## CITY of NOVI CITY COUNCIL

Agenda Item 1  
July 7, 2014

**SUBJECT:** Consideration of a request from Mirage Development, LLC for a variance from the following ordinance sections: 1) Subdivision Ordinance Section 4.05(A) requiring that pedestrian safety paths be constructed along both sides of local streets (a sidewalk on only the north side is proposed), 2) Section 11-94(c) to provide less than three feet of cover for storm sewer pipe, 3) Section 11-194(a)(7) for exceeding the 800 foot maximum length of a cul-de-sac (975 feet is proposed), 4) Section 11-194(a)(19) for the lack of a secondary or emergency access; as part of the site plan for Orchard Hills North single family residential development (parcel 22-26-201-006).

**SUBMITTING DEPARTMENT:** Department of Public Services, Engineering Division <sup>RH</sup> <sub>RLC</sub>

VARIANCE REQUESTS PLAN  
 ORCHARD HILLS NORTH CONDOMINIUM  
 PART OF THE N.E. 1/4 OF SECTION 26,  
 T.1 N., R.8 E., CITY OF NOV, MI  
 OAKLAND COUNTY, MICHIGAN

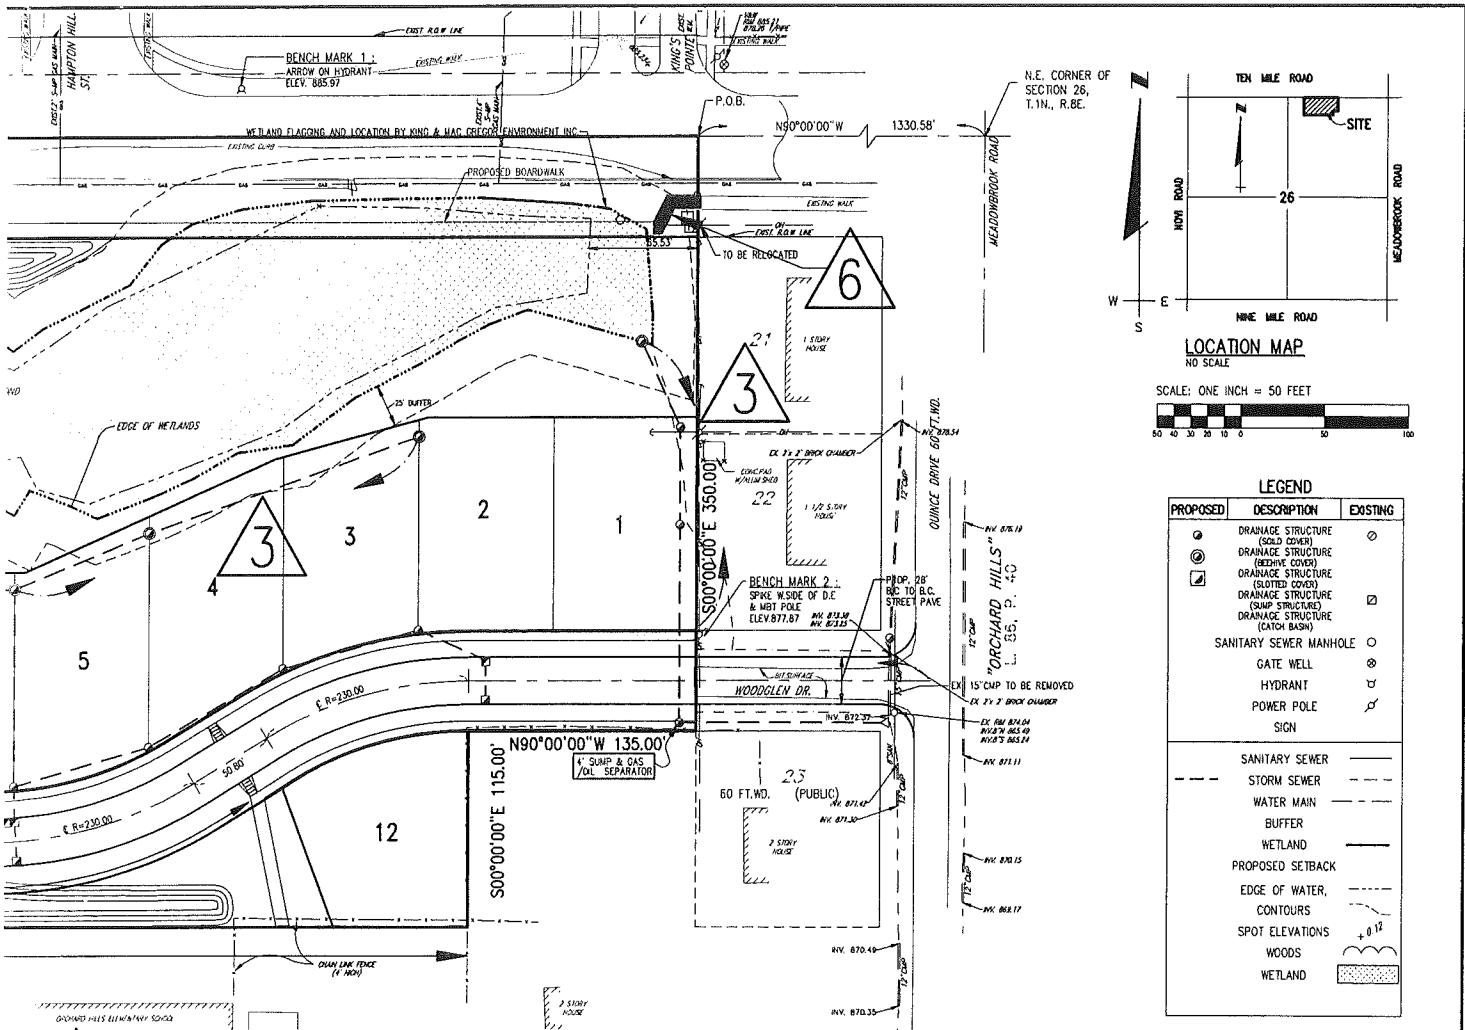
- 1** A City Council waiver for having a sidewalk on only one side of Woodglen Street:

- This waiver was granted by City Council on 11-14-05.
  - The reason for this request is that the sidewalk would serve no purpose, as there are no homes for the sidewalk to serve.

- The reason for this request is that there are several runs of storm sewer which, in order to outlet to the sediment basin, cannot be placed to provide the three feet of minimum cover. Additional fill cannot be placed due to their location and topography.

- Previously granted 11/14/05.
- The reason for this request is that there are no places to provide external access due to the topographic and natural features of the site. In addition, the property to the west is an apartment complex with private drives and the property to the south is the school. As with the request for exceeding the 800 foot maximum cul de sac length, there will be only 12 proposed units.
